Safespill has made a significant design change related to the supply method for flushing manifold systems. The following design brief provides details on the new design, discusses the pros and cons of this design change, and discusses the potential impact on system performance regarding compliance with Factory Mutual (FM) requirements.

Existing Design

New Design

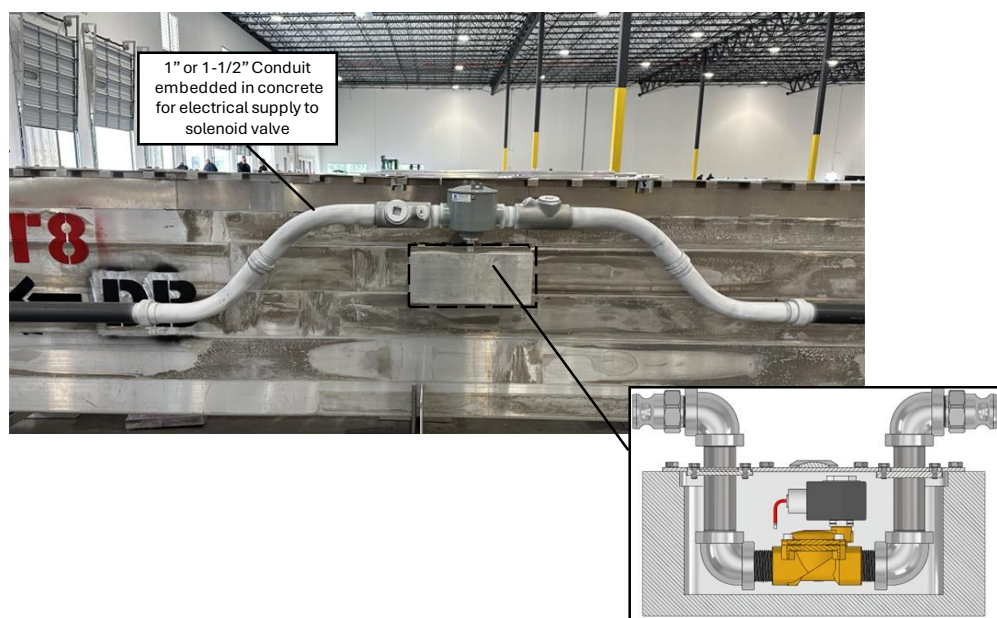
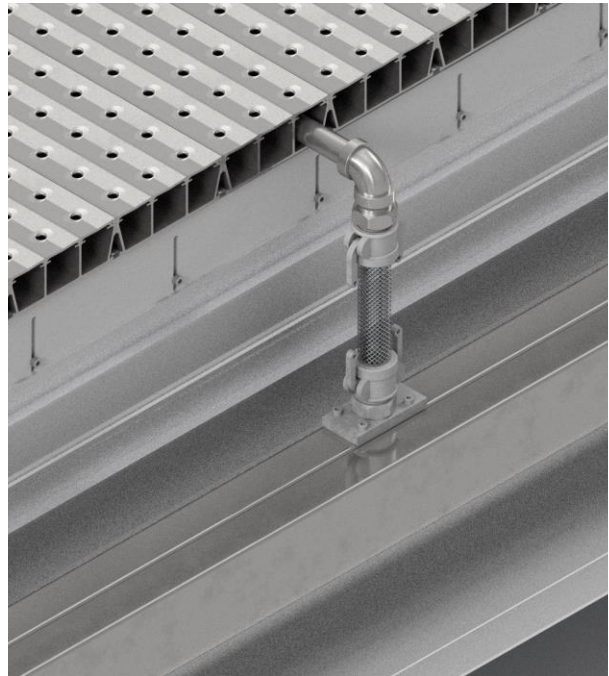
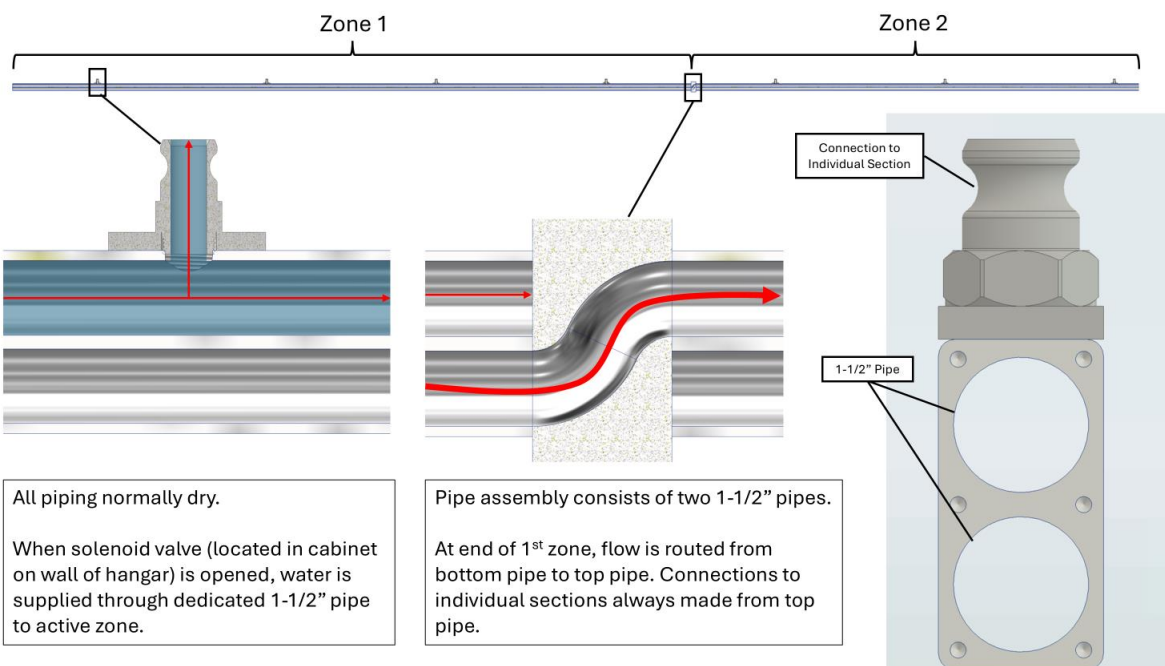
3" Supply Header is normally wetted up to solenoid valve for standard applications.
3" Supply Header is normally dry throughout for cold-weather applications.
Zone Header (Downstream of valve) is normally dry for all applications.

Solenoid Valves located outside of trench, housed in cabinet mounted on hangar wall.

Multiple pipe assemblies routed through trench with each pipe connected directly to flushing manifolds in the associated zone.
